MILITARY SPECIFICATION

CONNECTORS, PLUGS AND RECEPTACLES, ELECTRICAL, WATERPROOF,
QUICK DISCONNECT, HEAVY DUTY TYPE
GENERAL SPECIFICATION FOR

This amendment forms a part of MIL-C-22992E, dated 28 August 1974, and is approved for use by all Departments and Agencies of the Department of Defense.

FIGURE 1. Socket and pin, classes C, J and R.

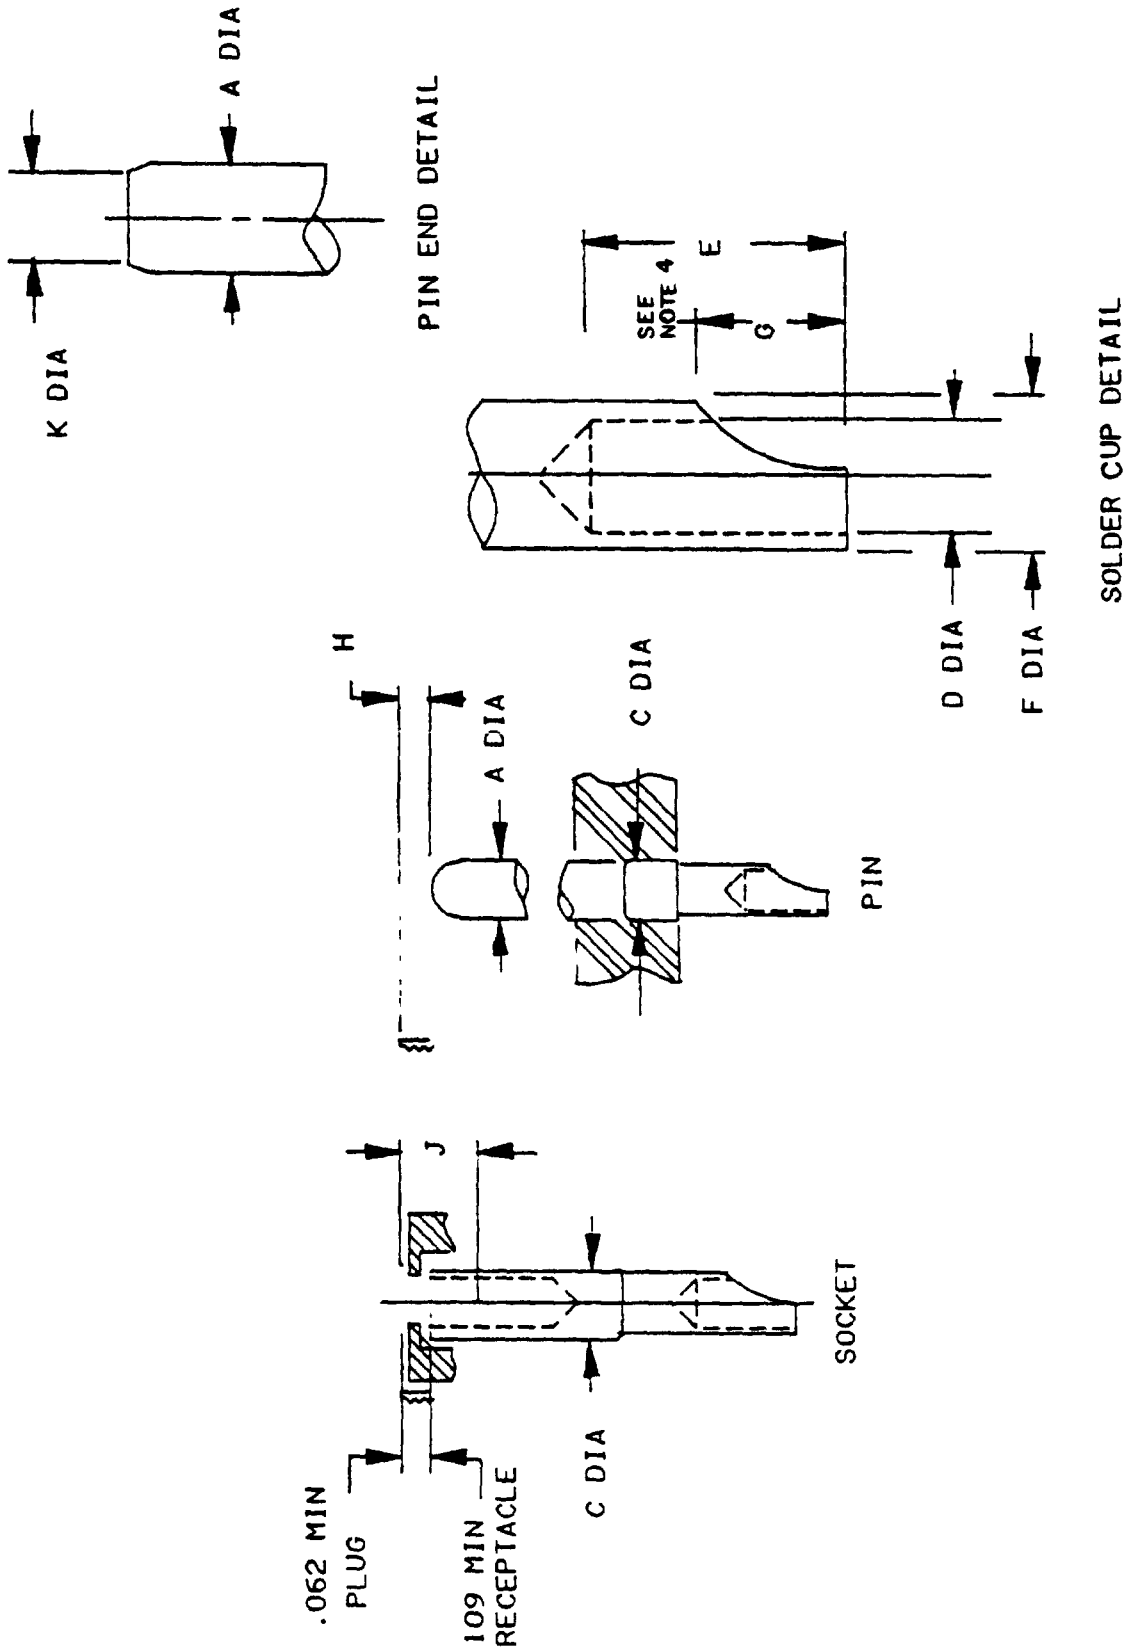
* FIGURE 1, delete and substitute new figure 1 as printed on pages 7 and 8 of this amendment.
